CITY OF ALBUQUERQUE

**Re: Signal Pointe Subdivision at Signal/Ventura (C20D070)
Grading and Drainage Engineers Stamp Date 9/15/2015
Engineer's Certification of Scour Wall dated 3-17-16**

Based upon the Certification received 3/18/2016, the As-Built Certification of the scour wall is not accepted for the following reasons:

DRAWING: **RETAINING WALL SECTIONS AND GENERAL
STRUCTURAL NOTES**

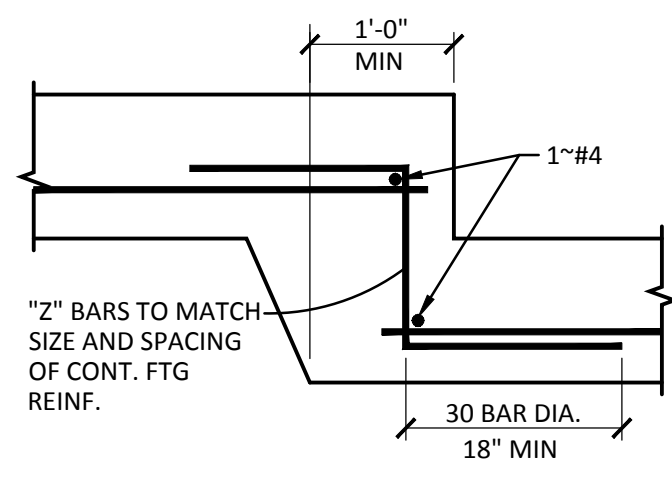
- Approval of the Grading Plan was conditional upon you providing wall details, calculations, and specifications. Only wall sections were submitted to Hydrology.
 - Wall sections do not show the scour line limits
 - The key has no reinforcing and with the 2' length dimension shown, significant reinforcing would be expected in a key of that length.
 - **Structural Calculations for the wall need to be provided.**
- Site inspection shows that the middle portion of the wall along the northern boundary is incomplete. Furthermore, there were 16" pilaster blocks sitting on top of 12 in wide CMU blocks with cells open to the dirt. **Structural Engineer responsible for the wall design should perform a site visit and provide an Engineer's Certification of the wall (not the Civil Engineer)**
- Fill and CMU debris were in the natural channel.
